One Up Sweaters Ltd.

21st May 2014

Building Observations

Level 2 Floor Plan

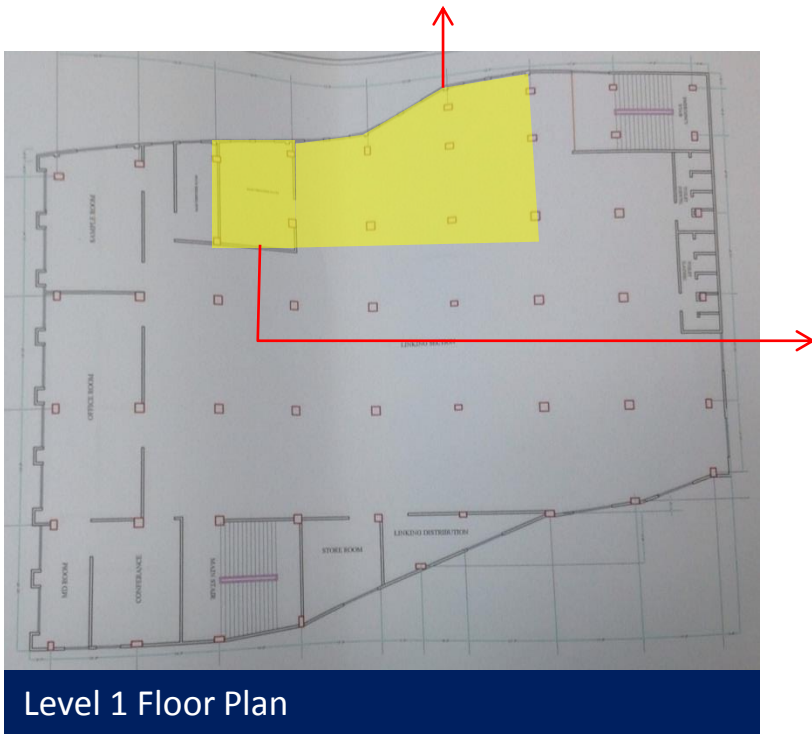
Local high stress levels in columns

Area designated to be 'Knitting Inspection' area instead used as storage. Load was applied to building edge where concrete slab cantilevers from column line.

- **No additional storeys may be constructed until the verification of column stresses is complete.**
- Building Engineer to review design, loads and column stresses at ground floor level.
- Verify in-situ concrete stresses either by 100mm diameter cores or existing cylinder strength data from min. 4 columns.

- Produce and actively manage a loading plan for all floor plates within the factory, giving consideration to floor capacity and column capacity.

Level 2 Floor Plan

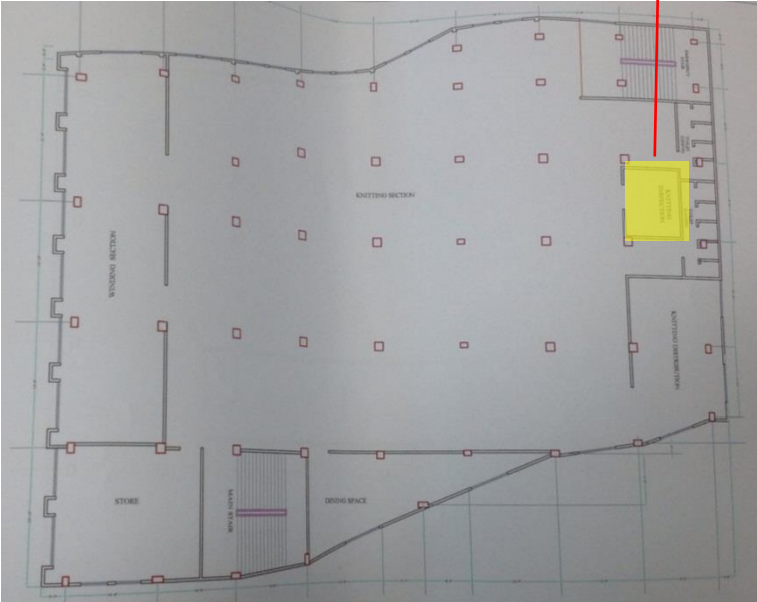
High storage loading on slabs

- Building Engineer to check the adequacy of structure against storage load.
- Building Engineer to review design, loads and stresses in RC slabs, including cantilevers. The slab check should include a punching shear check.
- Verify in-situ concrete stresses in the slabs either by 100mm diameter cores or existing cylinder strength data for cores from 4 locations remote from columns.

- Implement any strengthening / remedial works as required arising from slab checks.
- Input findings from slab checks into loading plan (see Item 1).

Permit Drawing – No Cantilevers shown.

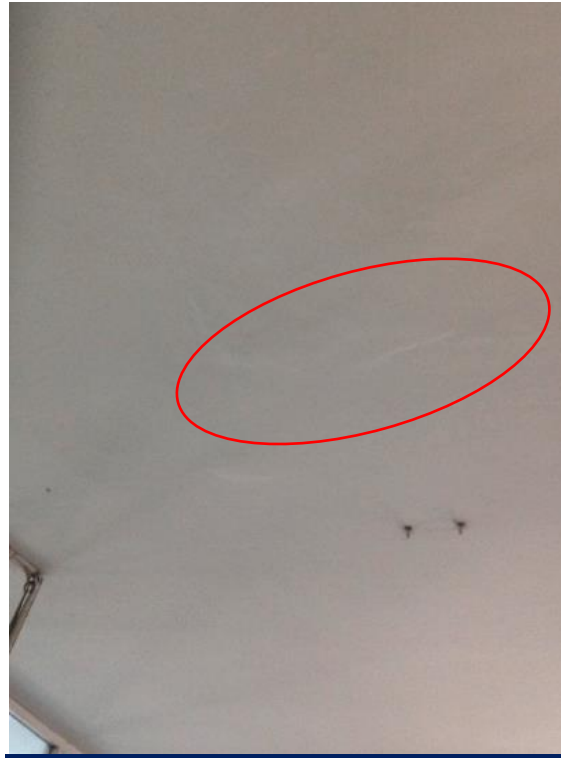
Discrepancies between drawings and observed structure

Structural Drawing – Cantilevers shown.

Permit Drawing – 8 Storey Building

- Building Engineer to survey building.

- Building Engineer to update all drawings to reflect as-built construction.

Ground Floor

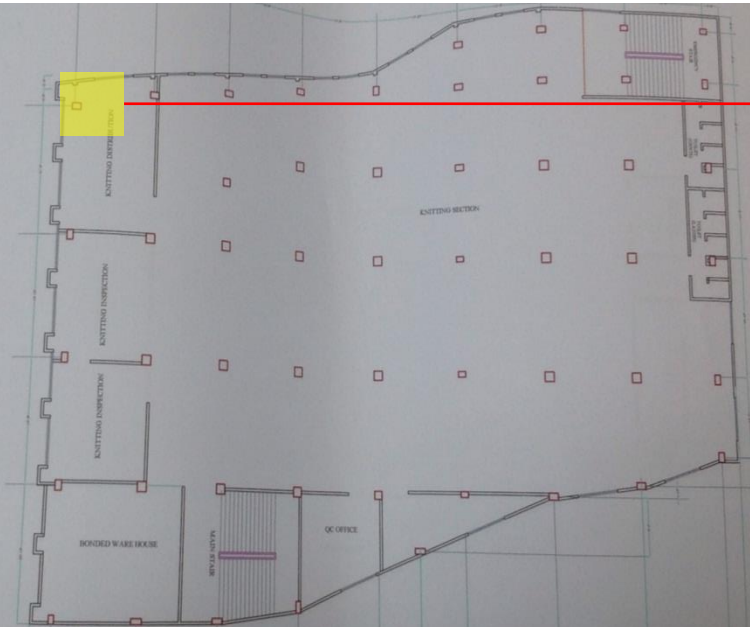
Localised crack along stairs descending onto Ground floor.
Crack is likely to be caused by poor construction.

- Building Engineer to assess extent and nature of cracking.

- If cracking is of a structural nature, Building Engineer to specify required structural repairs / strengthening.
- Structural repairs / strengthening to be carried out.

Level 2 and 3 Floor Plan

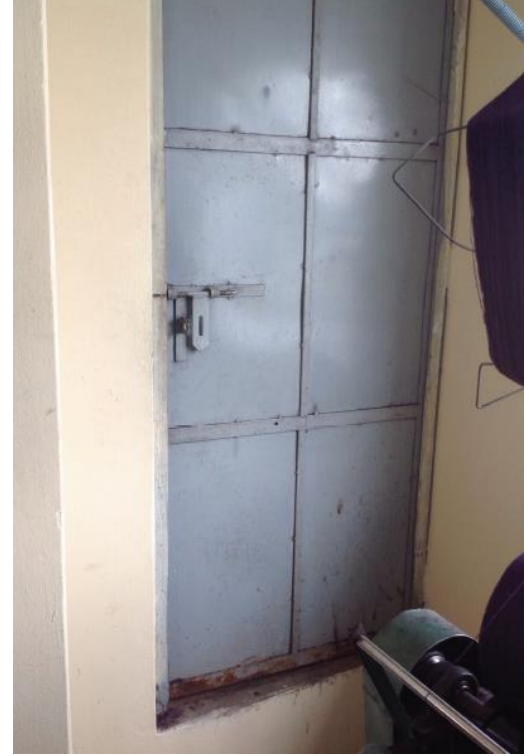
Additional concrete / steps build-up on slab

- Building engineer to check the adequacy of structure against additional load

- Implement any strengthening / remedial works as required arising from load checks.
